**Technical Service
BULLETIN**

**OCCUPANT CLASSIFICATION
SYSTEM INITIALIZATION
(DTC B1150 & B1650)**

'04 Camry, Highlander & Solara

REVISÉD
EL002-04
ELECTRICAL

Sensitivity Check Procedure

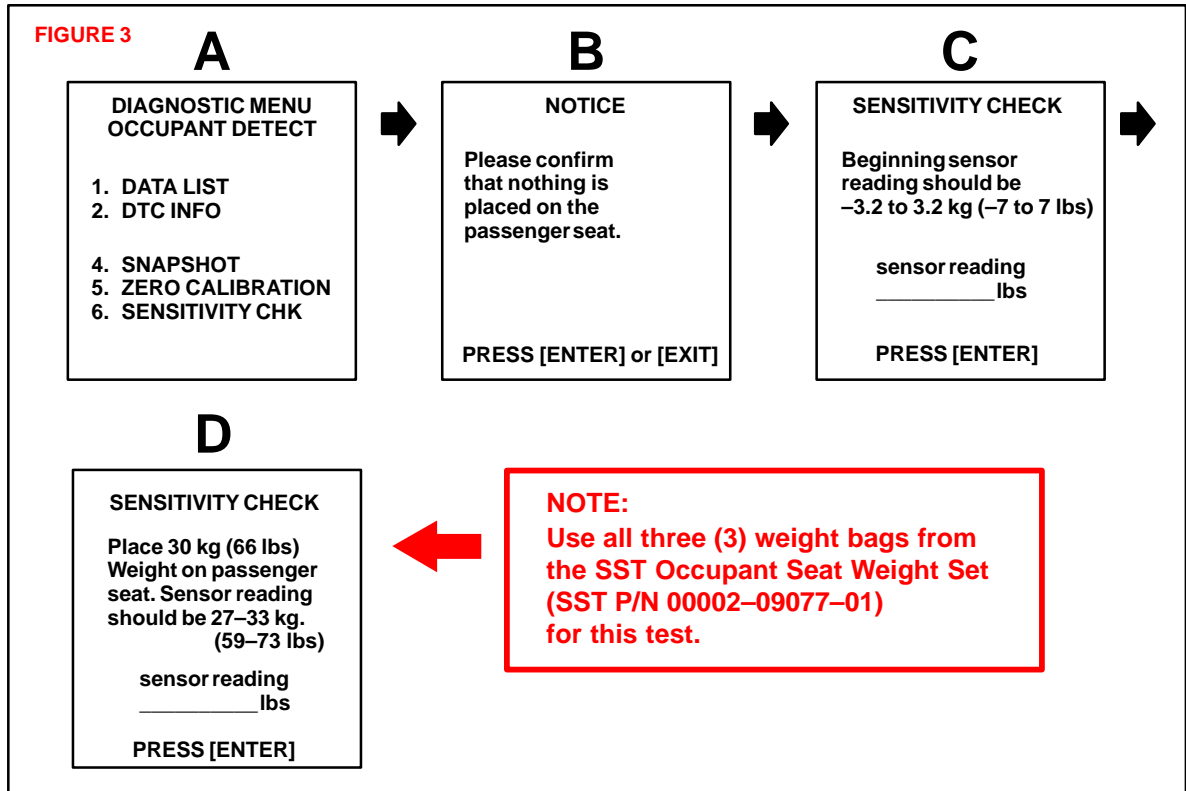
May 11, 2004: Introduction has been clarified, OCS SRS codes identified, new SST "Occupant Seat Weight Set" (P/N 00002-09077-01) added to Required Special Service Tools, "Note" added to Figure 3 on page 4. Previous versions of this TSB should be discarded.

NOTE:
If your Diagnostic Tester reads in kg instead of lbs. you can change the units of measurement in the SETUP function of the DIAGNOSIS application. Select UNIT CONVERSION menu and then choose WEIGHT.
